Access Compliance Report

Public Rights-of-Way

(Curb Ramps)

Intersection ID: 11302	Main Street: MEADOWCLIFF_DR	Cross Street: STEPPING_STONE_DR	Location: E
ADA ID: 44324E6909EB	Ramp Type: BlendTrans1	Initial Pass/Fail: Fail	Overall Compliance: No
Severity Score: 8.75			
Codes/Mitigation Info/Possible Solution		Field Measurements/Component Compliance

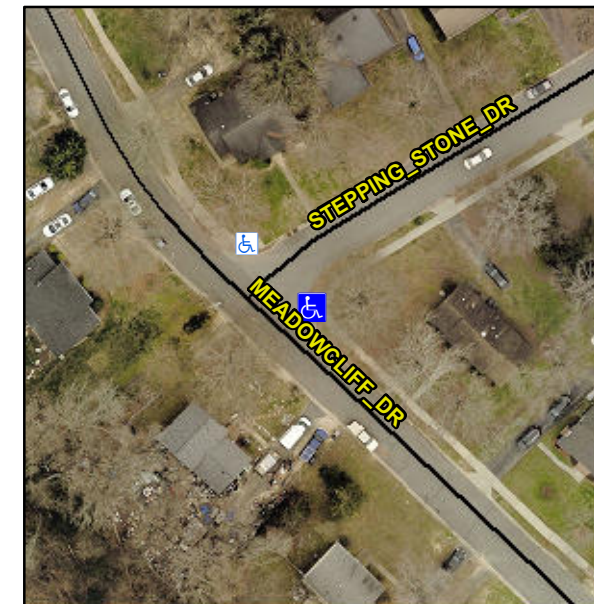
Not Found, R304.5.1

Compliance	Description	Data	Compliance	Description	Data
N/A	Ramp Length (in)	48.0	Yes	BlendTrans Slope (%)	1.0
No	Ramp Width (in)	47.0	Yes	BlendTrans XSlope (%)	0.4
N/A	Flare Type LT	N/A	N/A	Flare Type RT	N/A
N/A	Flare Slope LT (%)	N/A	N/A	Flare Slope RT (%)	N/A
N/A	Flare Traversable LT?	N/A	N/A	Flare Traversable RT?	N/A
N/A	Landing Length (in)	N/A	N/A	DWS Provided?	N/A
N/A	Landing Width (in)	N/A	N/A	DWS Contrast?	N/A
N/A	Landing Slope (%)	N/A	N/A	DWS Length (in)	N/A
N/A	Landing X Slope (%)	N/A	N/A	DWS Full Width?	N/A
N/A	Landing Curb? (Y/N)	N/A	N/A	DWS Offset (in)	N/A
N/A	Shared Landing?	N/A			
N/A	Gutter Ponding?	N/A	N/A	Gutter Slope (%)	N/A
N/A	Gutter Lip Ht (in)	N/A	N/A	Gutter X Slope (%)	N/A
N/A	Painted X Walk1?	No	N/A	Painted X Walk2?	N/A
	X Walk 1 Direction	To NW		X Walk 2 Direction	N/A
	X Walk 1 Width (in)	N/A		X Walk 2 Width (in)	N/A
	X Walk 1 Slope (%)	0.2		X Walk 2 Slope (%)	N/A
	X Walk 1 X Slope (%)	1.1		X Walk 2 X Slope (%)	N/A

N/A	Ramp inside XWalk1?	N/A	N/A	Ramp inside XWalk2?	N/A
	Road Slope (%)	1.1		Clear Space?	N/A
	Road X Slope (%)	0.2	N/A	Clear Space to XWalk (in)	N/A
N/A	Any Obstructions?	N/A	N/A	Storm Grate/Utility Hazard?	N/A
	Obstruction Type			Storm Grate/Utility Type	
		N/A			N/A
			Yes	Surface Condition? (G/P)	Good
			No	Curb Slope (%)	13.0

Remove & Replace Curb Ramp With Two New Directional Ramps or Equivalent.
